**AMENDMENTS TO THE DRAWINGS**

**REMARKS****Disposition of Claims**

FIG. 3E

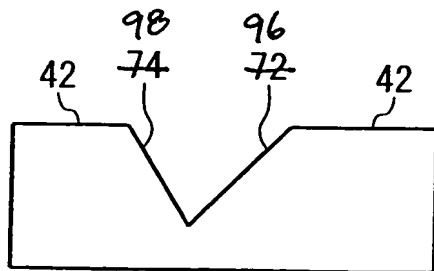
The drawings are objected to as failing to comply with 37 C.F.R. 1.84 (p) (5) because they do not include the following reference sign(s) mentioned in description: 96 and 98, The drawings have been amended in this reply in view of this objection. Accordingly, withdrawal of this objection is respectfully requested.

Please amend the figures as shown in the enclosed replacement sheets. The proposed changes include: adding an additional instance of reference numerals “96” and “98” to Figure 3E in place of reference numerals “72” and “74” respectively. No new matter is added in the substitute drawings.
